SUBJECT: **TND-C-1-06 Final Development Plan Major Change & Preliminary Plat of 259 Lots for the Remaining Portion of Village at Magnolia Square Traditional Neighborhood Development**

SUBJECT: **TND-C-1-06 Final Development Plan, Development Review Committee (DRC)
Comments – Applicant Response**

SUBJECT: TND-C-1-06 Final Development Plan, TND VMS Additional Comments – Applicant Response

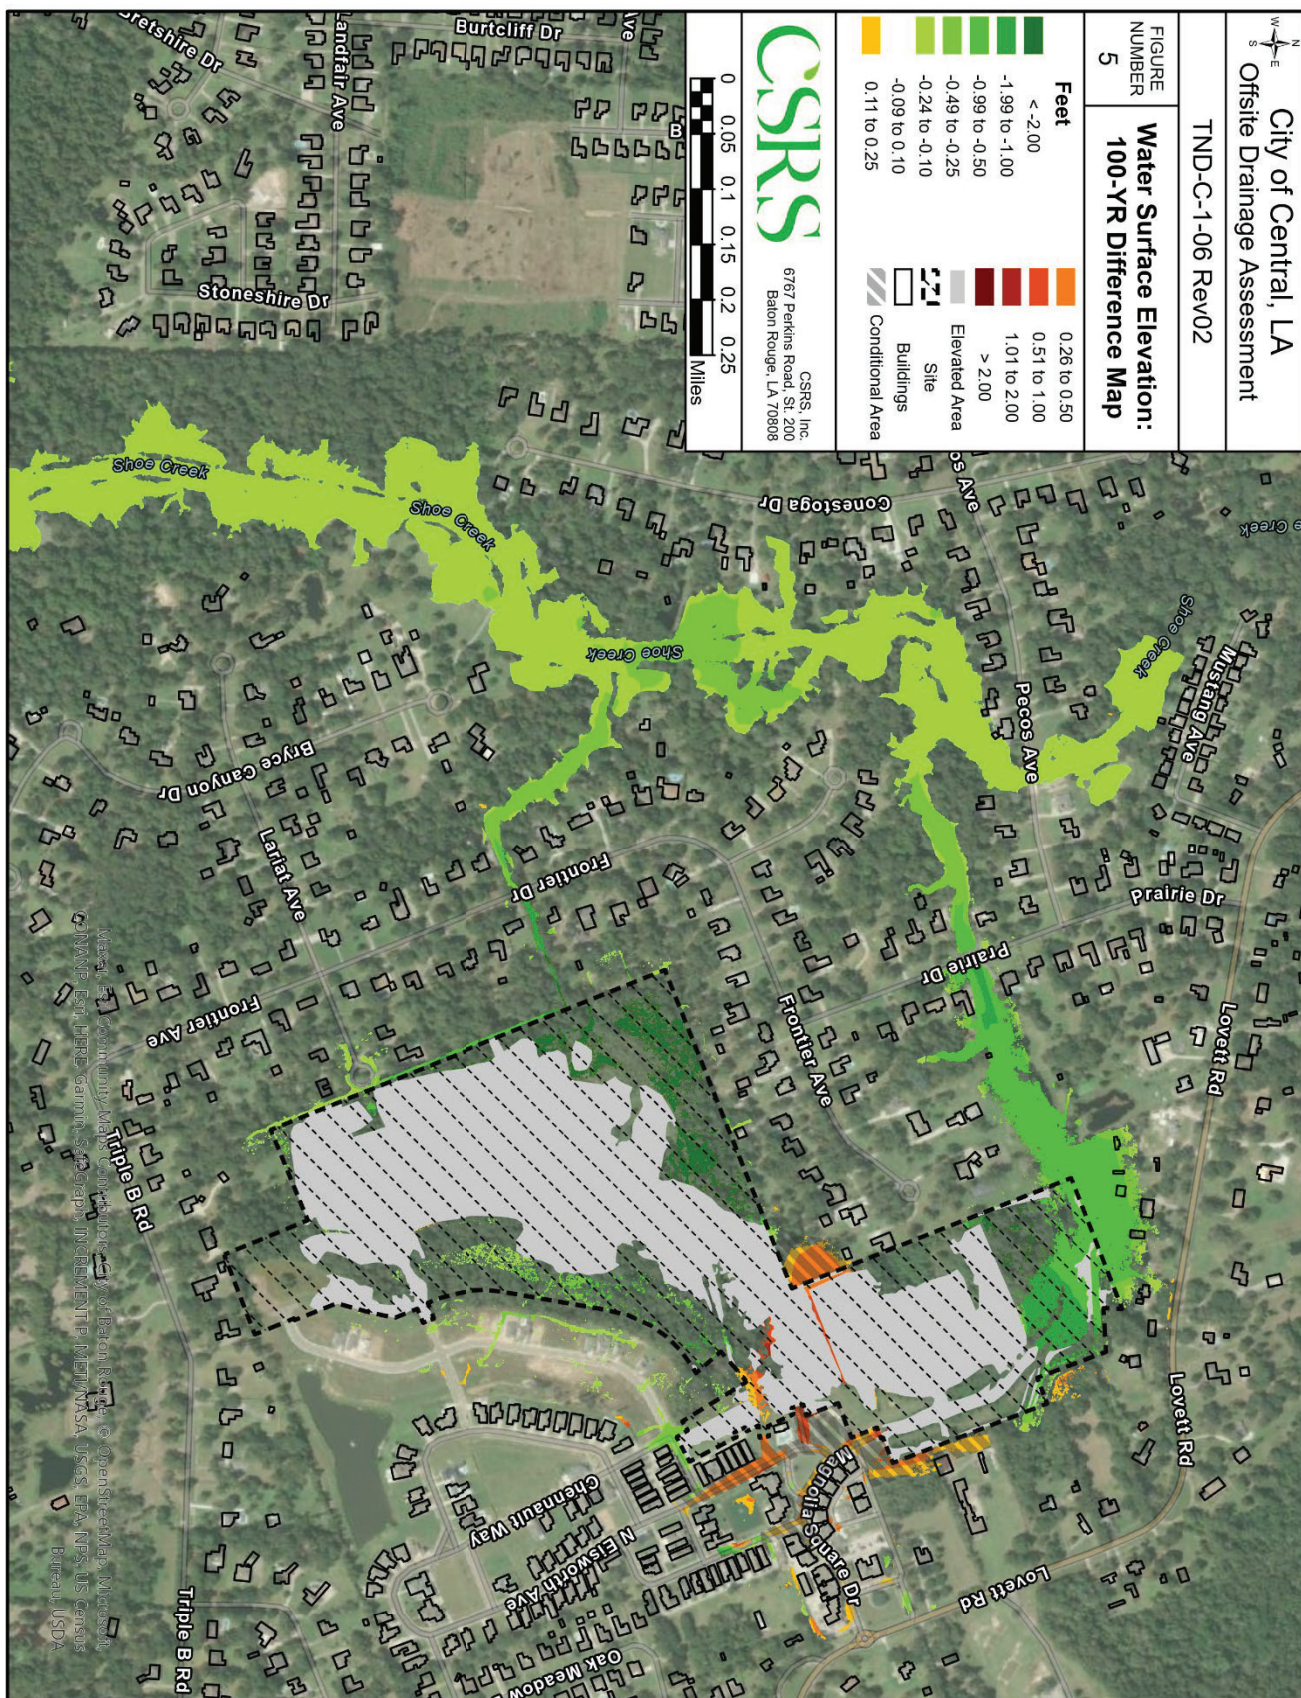
The peak water surface elevations from each storm event were extracted from the Updated EHM and Post-Development Hydraulic Models and compared to one another as shown in *Figures 3, 4, and 5*.

The comparisons reveal the following impact to peak water surface elevations beyond the development site for all storm events:

-
- Decreases between 0.1 and 2.0 feet along Shoe Creek downstream of the site and directly downstream of the pond outfalls.

The comparison also revealed the following impacts to peak water surface elevations beyond the development site for all storm events, however, after review with the applicant, the current proposed development does not have the detailed layout necessary for the ODA to accurately reflect capturing the surface runoff which results in revealing these impacts. It is suggested that these impacts be reevaluated after the applicant is allowed to further design the development.

- Increases between 0.1 and 0.5 feet in the back of adjacent lots on the Southside of Frontier Ave; and
- Increases between 0.1 and 0.5 feet in the back of adjacent lots on the Westside of Lovett Rd near the proposed extension of Magnolia Square Rd.
